*STP-209-1(2) Roadway and BHF-209-1(3) Bridge  
Widening of SR 74 From SR 85 to*

*P.I. Nos. 322355 and 322357*

**Value Engineering Study Report**

Preliminary Design Stage

Sht. 7 of 16  
ORIGINAL DESIGN

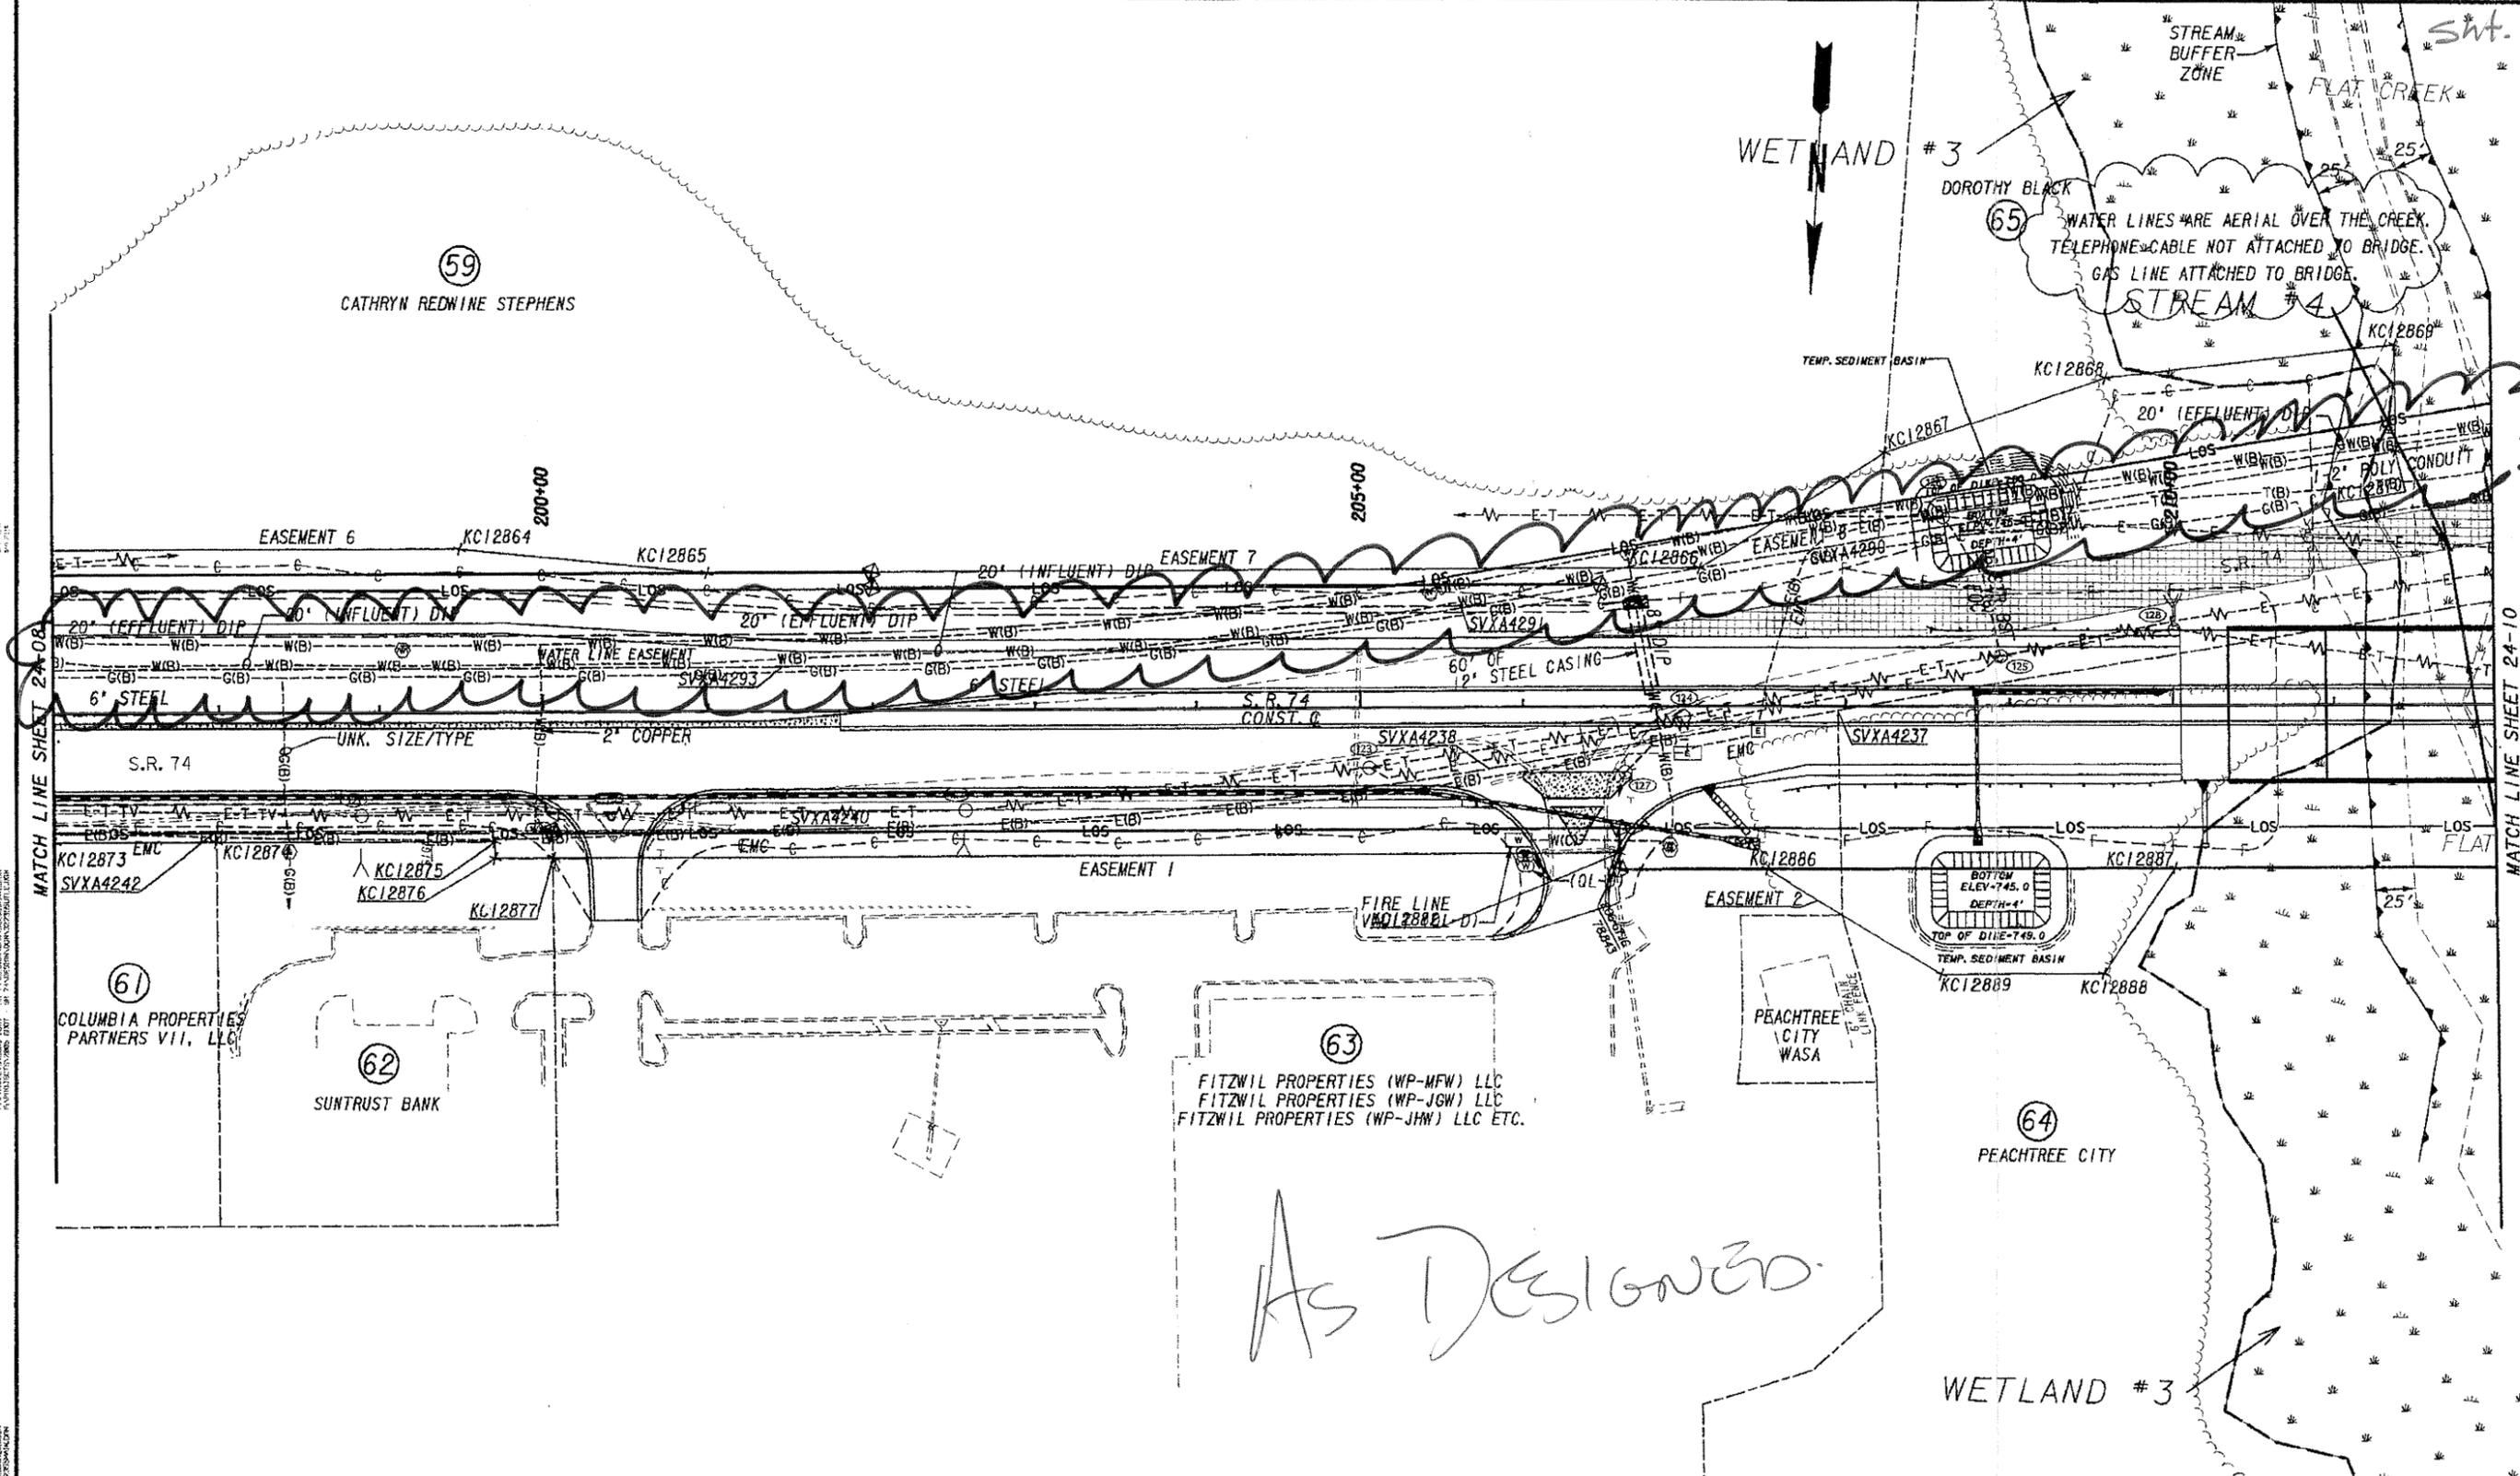
The current design assumes that the water lines are inexpensive and easy to relocate. The lines are trunk lines from the Peachtree City Water Treatment Plant. An effort has been made to avoid these lines outside of the station limits below.

With housing distances from the road often exceeding 100 ft., there does not appear to be a valid reason why the horizontal alignment can not be shifted to avoid the water lines. The right-of-way costs would not appreciably change, but amounts would be shifted from one side to the other.

Sht. 8 of 16  
ALTERNATIVE DESIGN

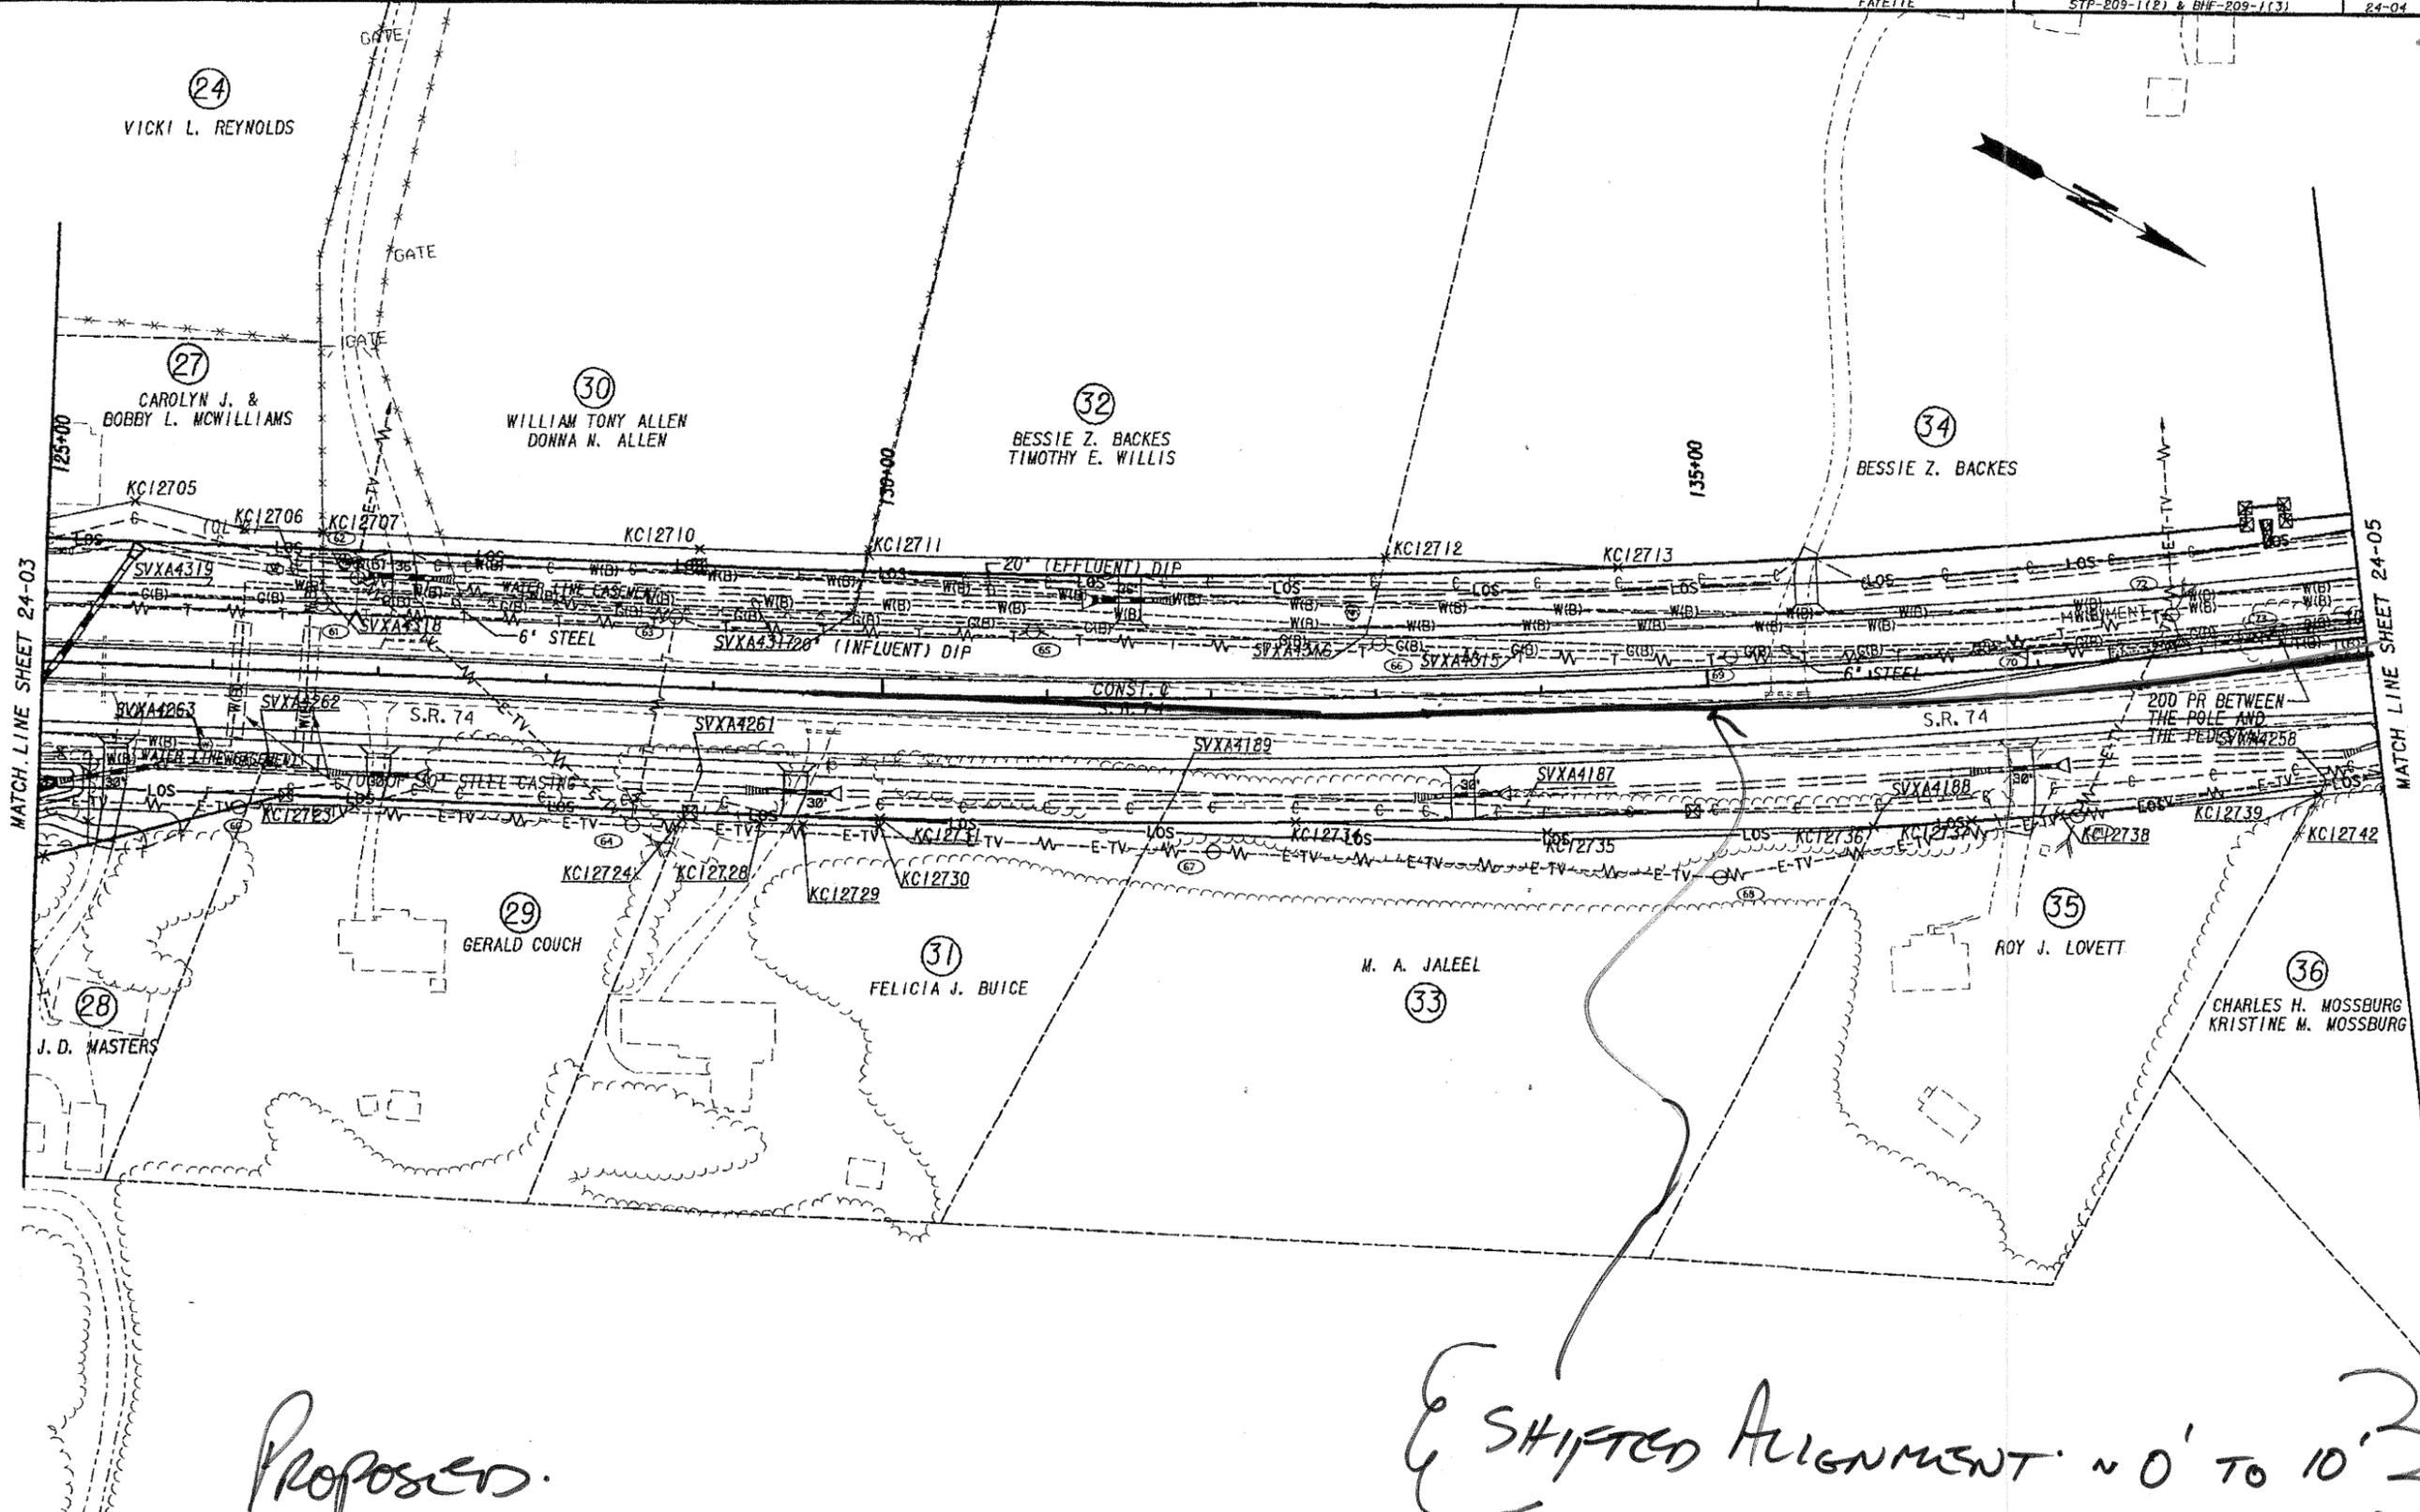
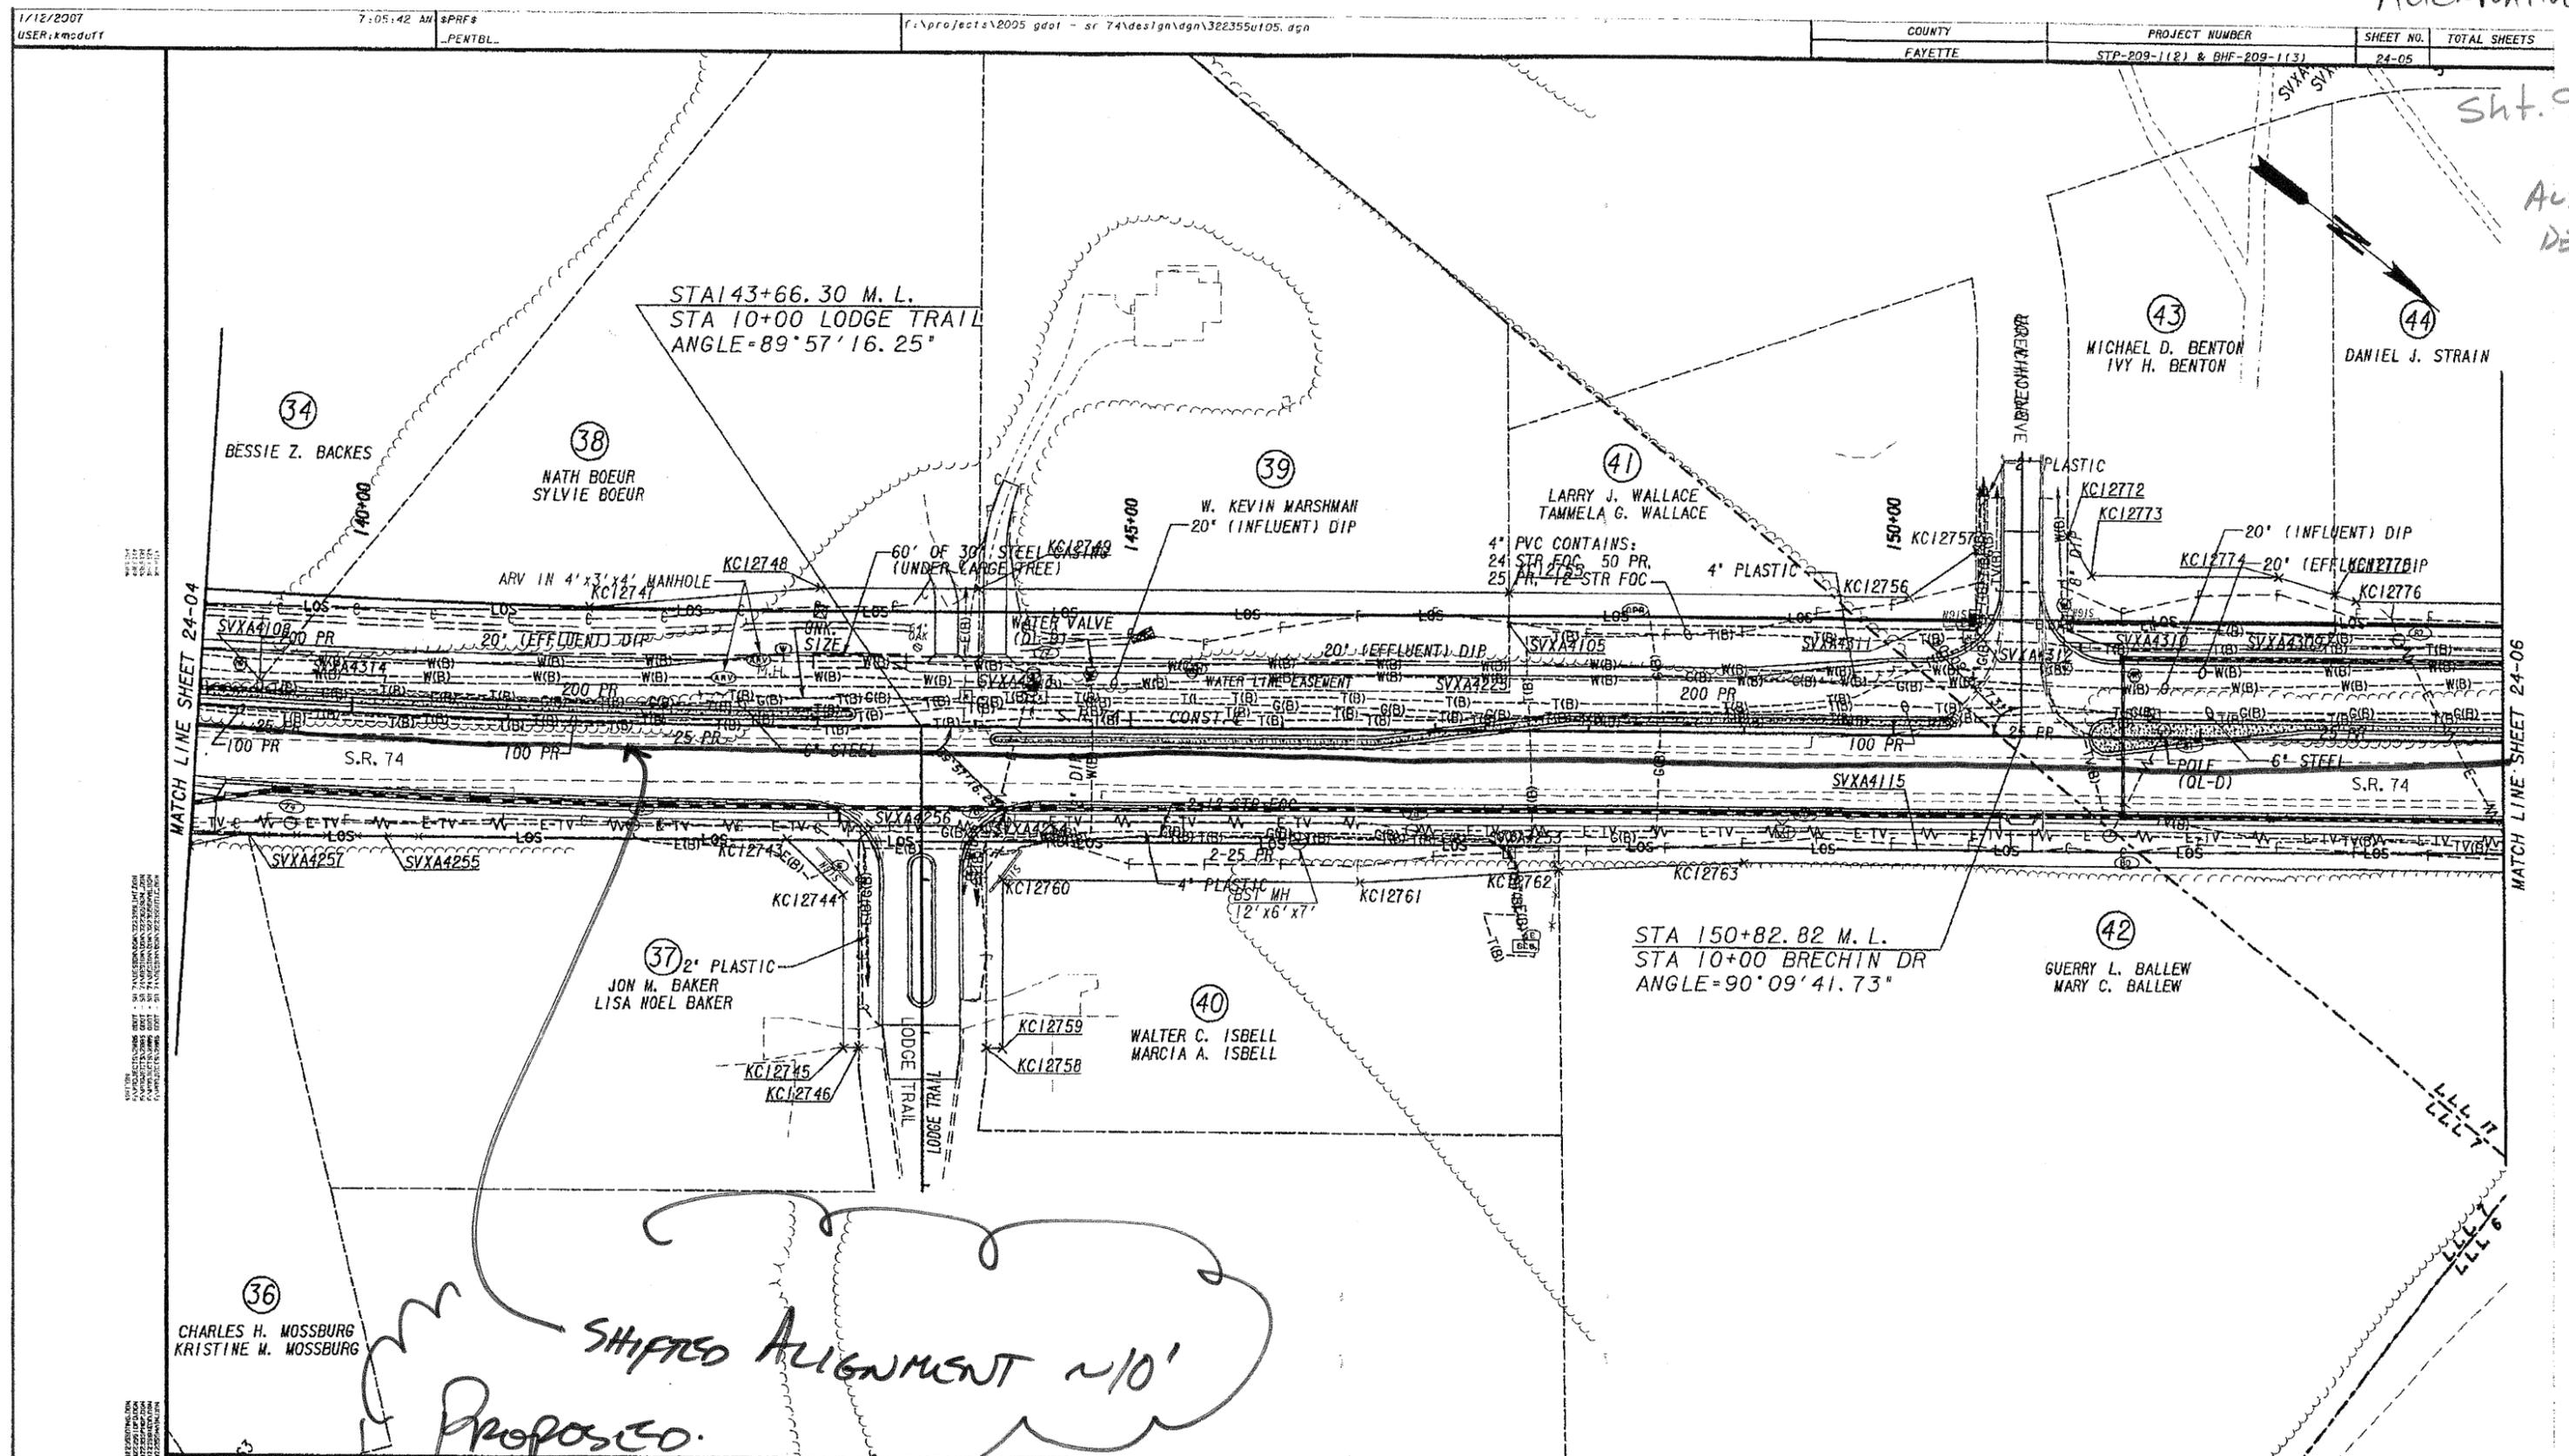
Not up to date  
Propose shifting  
new alignment to miss  
water lines.
